Interactive comment on “Tracers and traceability: implementing the cirrus parameterisation from LACM in the TOMCAT/SLIMCAT chemistry transport model as an example of the application of quality assurance to legacy models” by A. M. Horseman et al.

Received and published: 3 February 2010

Fig. 1. Revised waterfall software lifecycle diagram.

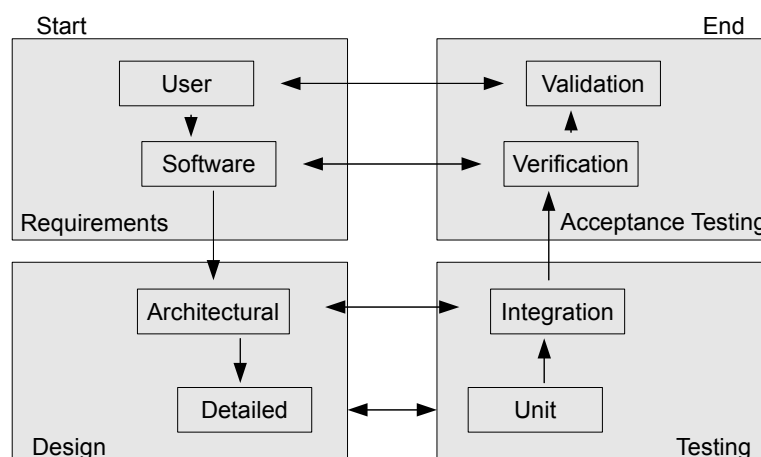
Figure 1: In order to reflect the discussion in the text, this figure could become more illustrative to group boxes according to 'Requirements', 'Testing' and 'De-

sign’. Also the term ‘Revision/configuration control’ should appear. I’m wondering whether the ‘design’ task could be explained in the manuscript as well with an own section

The diagram has been amended accordingly (see attached). The difficulty in incorporating the terms revision/configuration control is that it encompasses all the stages shown so they are difficult to represent on the diagram. This reviewer comment does point out that we omitted the word ‘documentation’ from the list of items to be included in configuration control in section 2.2.3. We have now added this. The addition of a design section is more problematic when using legacy models. In our example case most of the design stage applied to the legacy models and nearly all the existing design information has been lost. It is difficult to prescribe a design process as this, of all the development stages, is the most dependent on what detail and documentation is available for the legacy code. It would therefore be the developer’s decision what to do. We would anticipate that the most likely case is that we already describe.
